VSP-30
May 20, 1981

VENDOR SERVICE PUBLICATION

Subject: Bendix Service Bulletins 599A, 609A, 610,
613, 614

SERVICE BULLETIN NO. 599A
(Supersedes Service Bulletin No. 599)
Engineering Aspects are
FAA Approved

Figure 1.

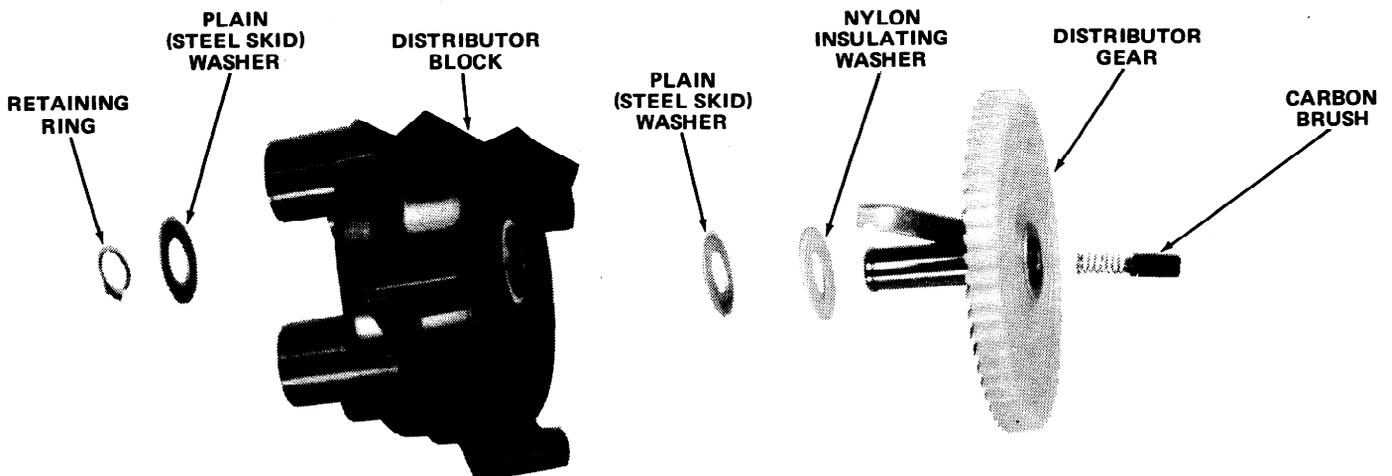
REASON FOR BULLETIN: To announce availability of an improved insulated distributor gear (kit) for the subject magnetos.

This bulletin announces availability of an improved, insulated distributor gear in kit form which is interchangeable between the D-2000/D-2200 & D-3000/D-3200 series magnetos. The kit includes all parts (except distributor block) as identified in figure 1.

Assembly sequence of the gear kit to distributor block is shown in Figure 1.

Figure 1. Location of Identification Mark

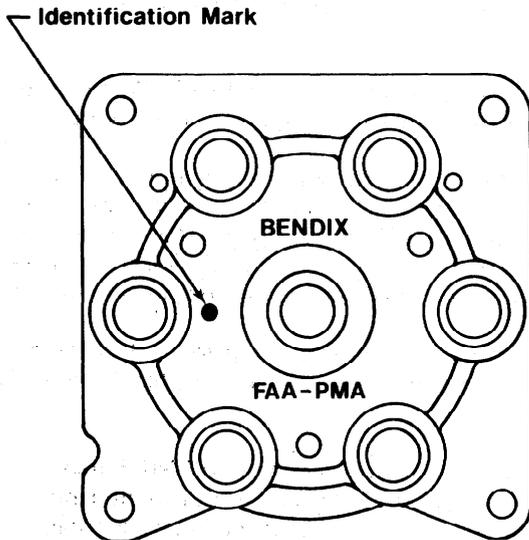
1. To announce the availability of an improved Diallyl Phthalate (DAP) green distributor block incorporating a new design "Gripper" oilite bushing.
2. To alert users of a possible loose oilite bushing in the original green DAP distributor block. Field reports indicate that the bronze oilite bushing in the current green distributor block may become loose and turn within the block. This condition could wear the block enough to cause the distributor gear to become mistimed resulting in rough engine operation.
3. To provide instructions for inspection and/or replacement of the original green distributor blocks with the new "Gripper Bushing" green distributor blocks as required.

The new "Gripper Bushing" will eliminate the possibility of the bushing becoming loose. The "Gripper Bushing" block can be identified by a circular shaped mark 0.188 inch \pm 0.031 inch in diameter raised 0.010 inch to 0.030 inch above the surface of the block. This mark is located on the tower side of the block, as indicated in figure 1.

Figure 6. Distributor Gear/Block Exploded View

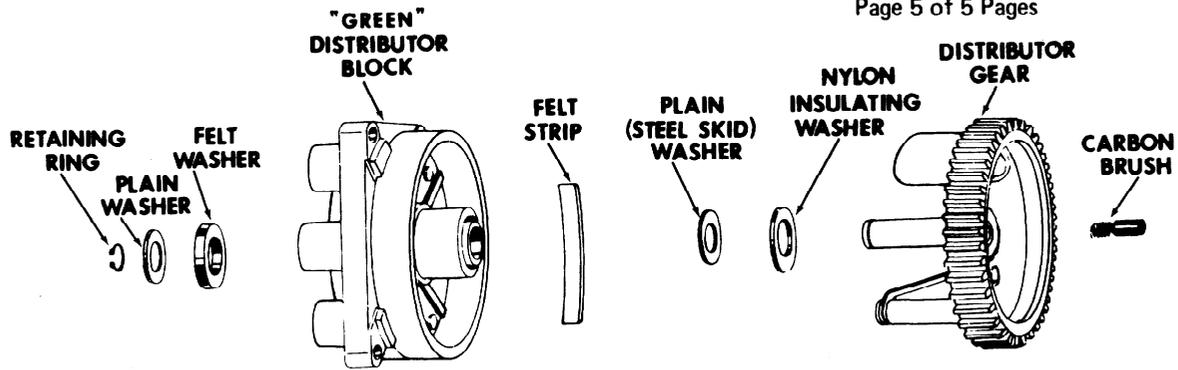
8. For reassembly, reference figure 6 and proceed as follows:

Figure 1 Defect

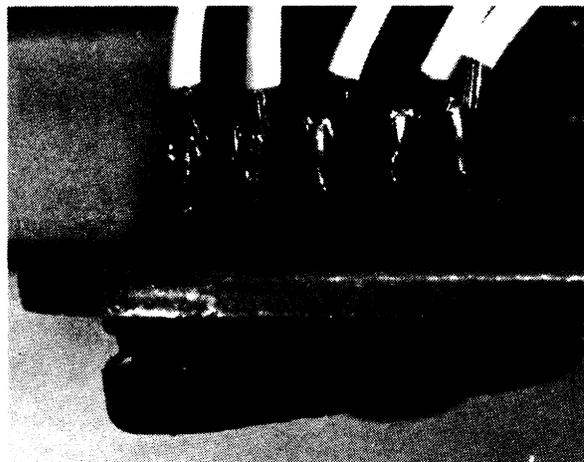
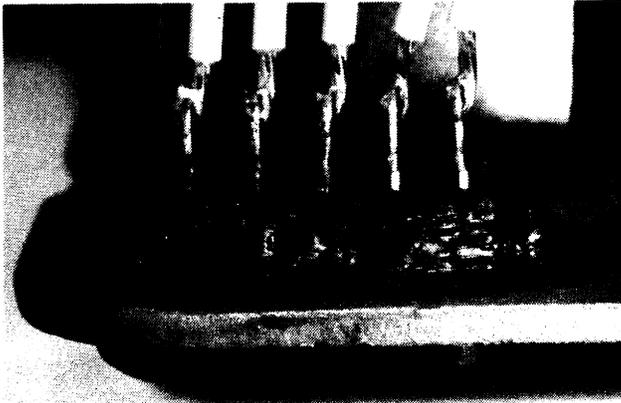
Bushing (connector), P/N 10-382943, may become loose in the vibrator plate and cause the grounding of both magnetos with possible loss of ignition. See figure 1 (defect).

5. Use RTV (Silicone rubber sealant, or equivalent, Dow Corning Corp., Midland, Mich. 48640) to seal terminal bushing to the mounting plate. Apply a small bead completely around the bottom of bushing to secure the bushing to the plate as shown in figure 2 (repaired). If RTV is not available, use either Hysol, Epoxi-Patch Kit (general purpose), Hysol Corp., Olean, NY or Conap, Easyoxy Kit (K20 general purpose) 1405 Buffalo St., Olean, NY, or equivalent.
